**231 Goldhurst Terrace,  
NW6 3EP**

**Basement Impact Assessment  
Audit**

London Borough of Camden

Project Number: 12066-33  
Revision: D2

(b) Influence of horizontal strain on  $\Delta L / \epsilon_{lim}$  (after Burland, 2001)

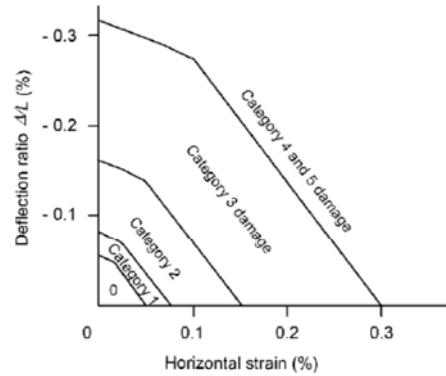
- The figure at the start of the GMA appears to show the property being underpinned as opposed to the neighbouring property being assessed for movement. It is not clear which building /part of building is being assessed.

The figure is an indicative representation of the property; however the diagrams below represent movement at distance up to 10.4m from the property, therefore includes the potential movement of the neighbouring property.
